31/07-05I 10009 Menlo Ave
Capitol View Historic District

CASE NO. A-6152

Memorandum**Date: September 5, 2006****To: Tania Tully, Historic Preservation Planner****From: Bill Karas****Info: Eric Gronning****Re: 1009 Menlo Avenue Variance Request****Case No. A-6152**VIA FAX

TO: Robert Hubbard, Director
FROM: Tania Tully, Senior Planner
Historic Preservation Section
SUBJECT: Historic Area Work Permit #397538

PROPOSED SECOND FLOOR PLAN

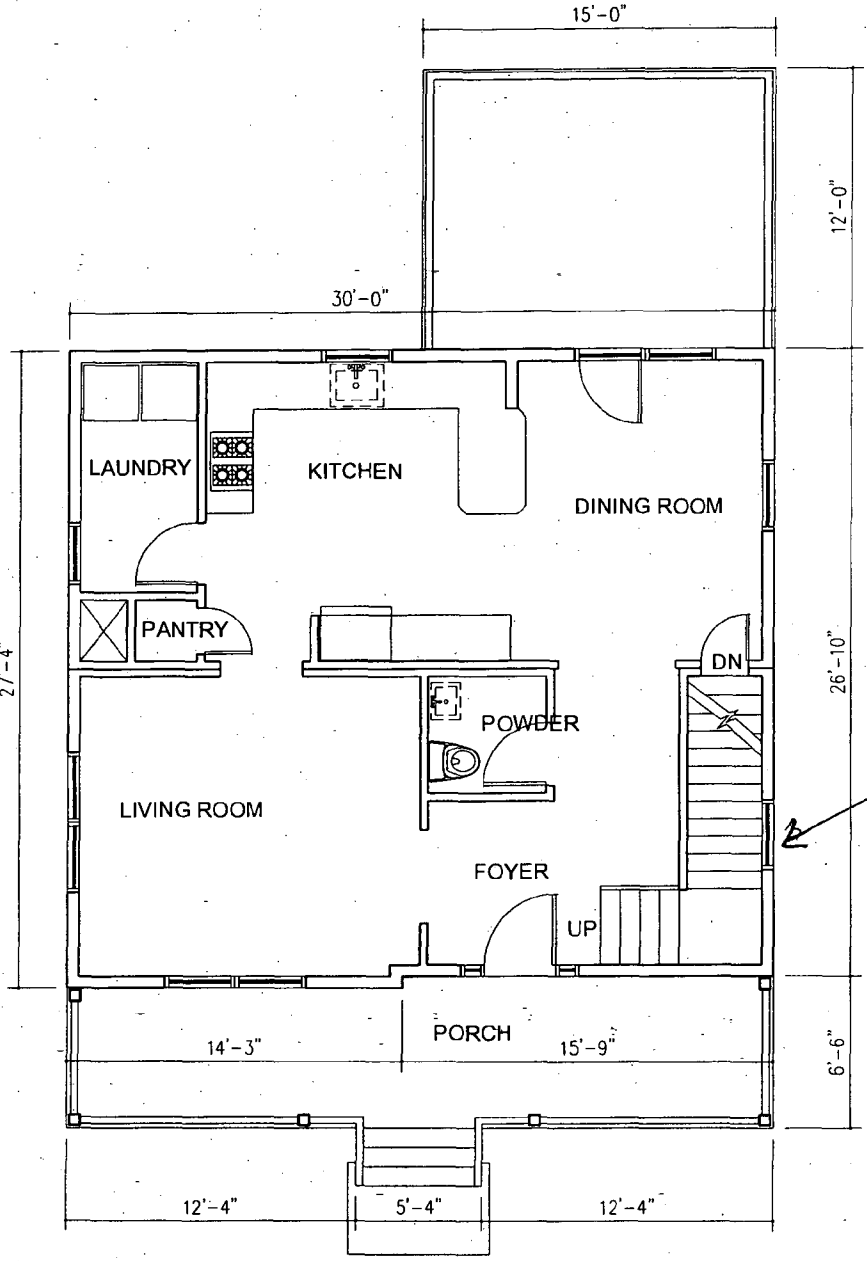
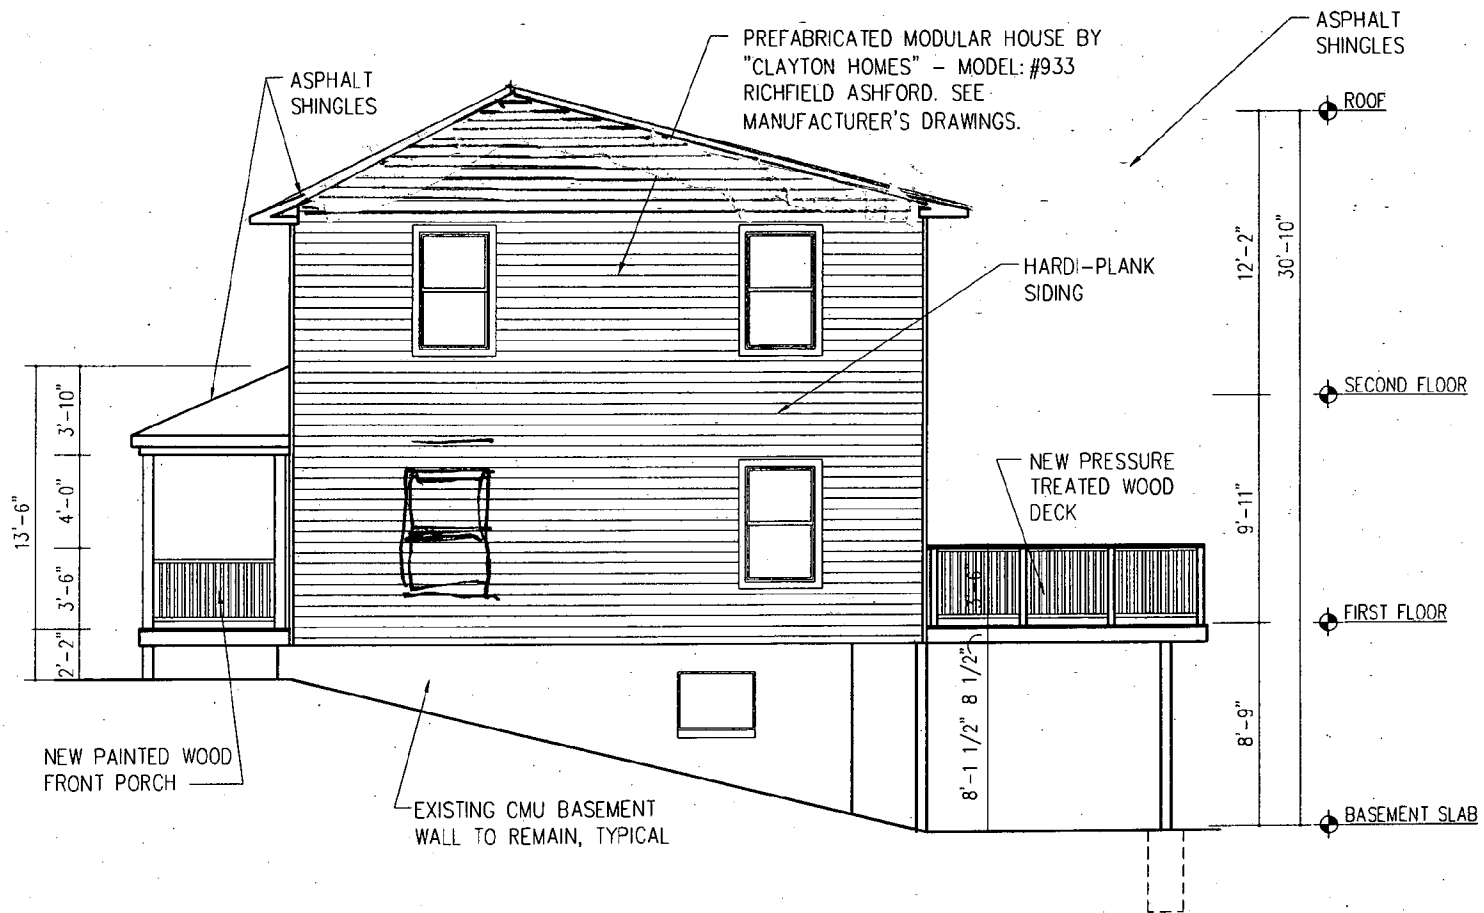
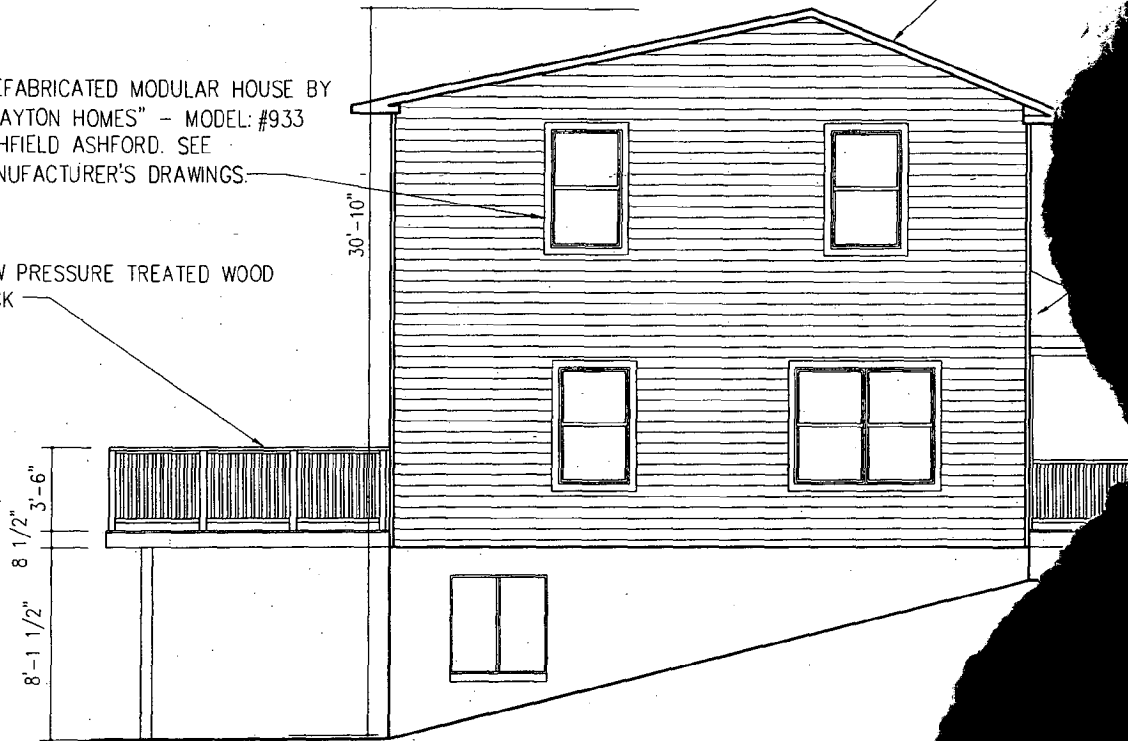
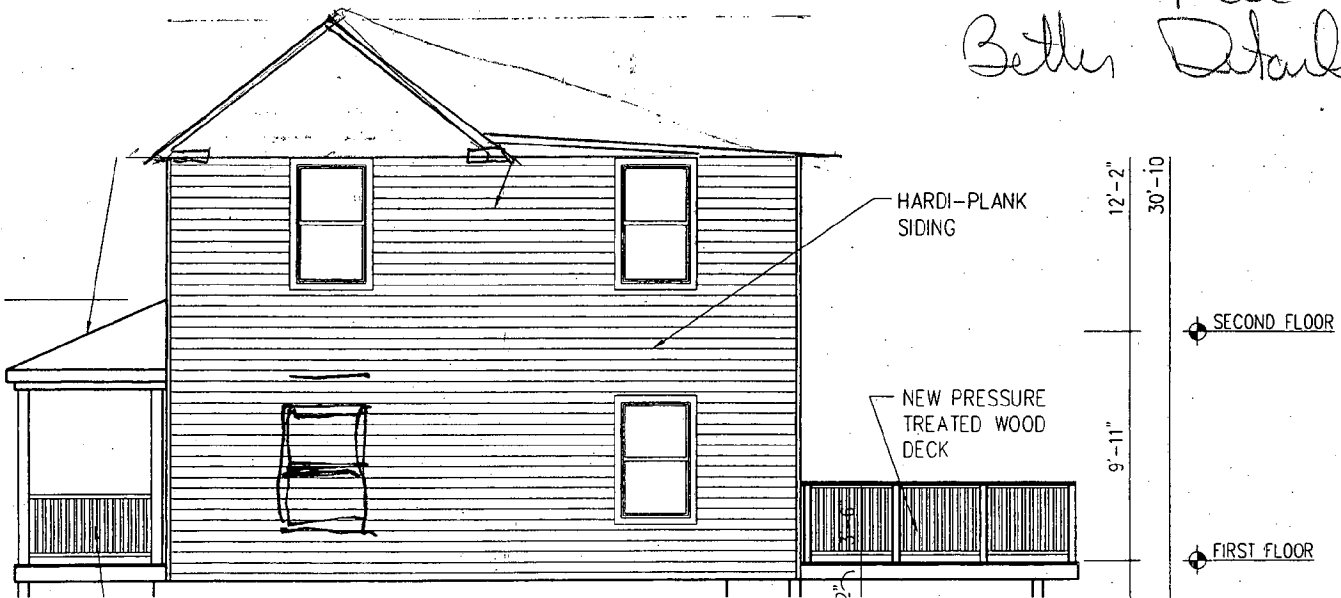
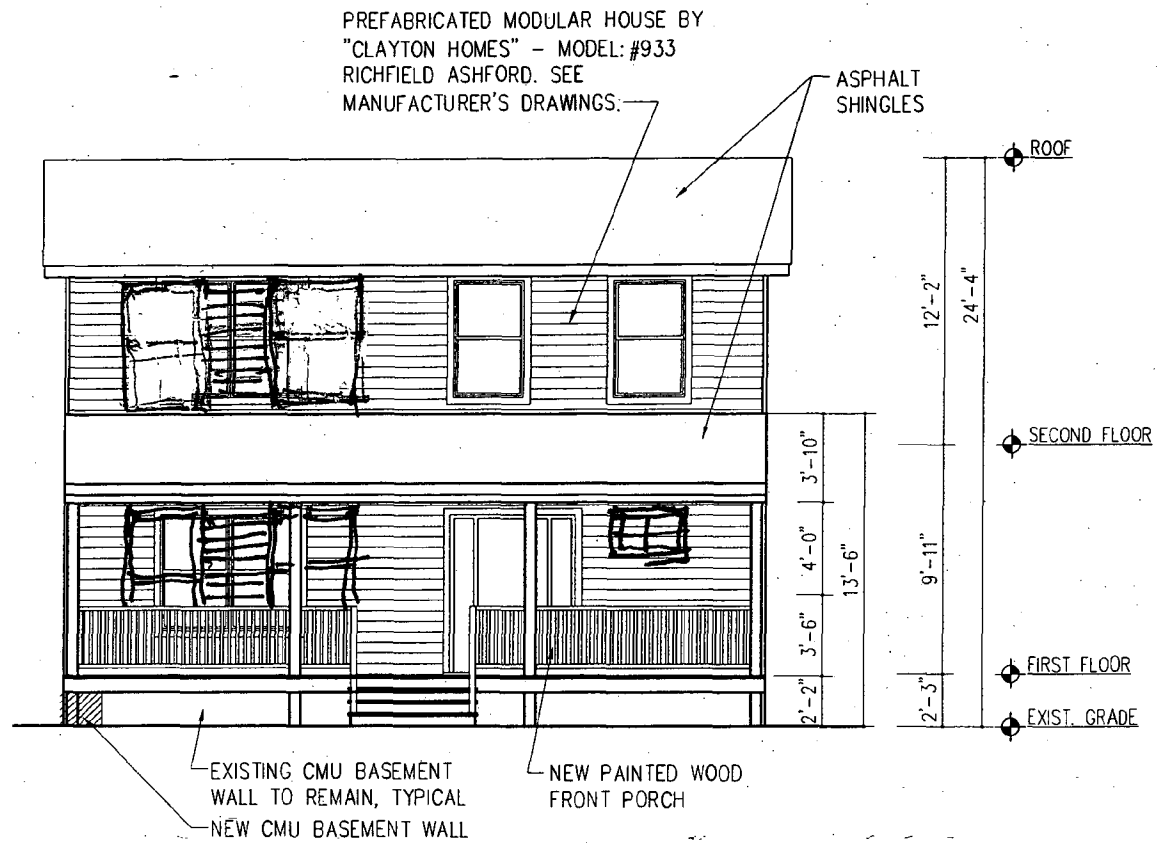
*not shown
on elev*

More traditional
Feel
Better Details
